Mercedes-Benz

Campaign No. 2017010006, March 2017

SUBJECT: **Model 190, Model Year 2016**
Check Automatic Transmission for Leaks, Replace if Necessary

Figure 1

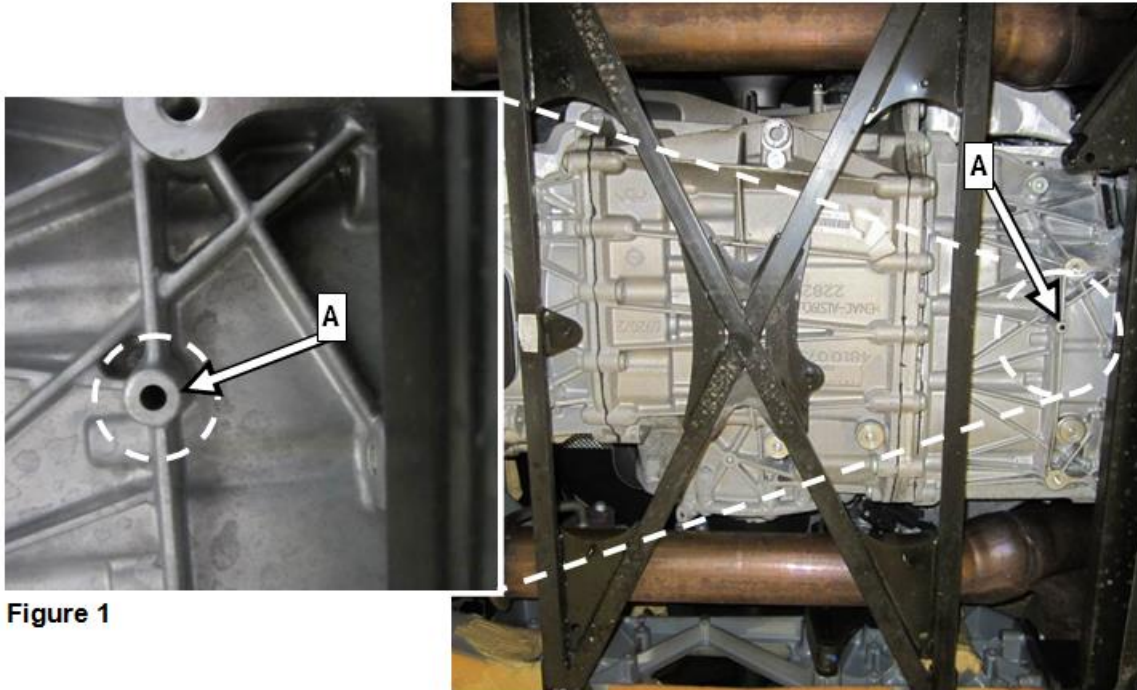
1.  Remove underfloor paneling under automatic transmission.
2.  Check ventilation bore (A, Figure 1) at bottom side of transmission for leaks.

- If transmission fluid is **NOT** leaking from ventilation bore (A) (**OK**): Procedure is complete.
 -  **Note:**  Reassemble in reverse order.
- If transmission fluid **IS** leaking from ventilation bore (A) (**NOT OK**): Proceed to  step 2.
 2.  Replace automatic transmission; refer to  WIS: AR27.10-P-0502MNB.
 3. Create PTSS case:
 - Submit pictures of old automatic transmission serial number and new transmission serial number along with VIN.
 -  **Note:**
 - Pictures submitted must be of good quality and high resolution (refer to Figure 2). Picture with bar code is preferred.
 - No SDS print out is required.
 - No further instructions will be provided. Do **not** select check box for information only case.
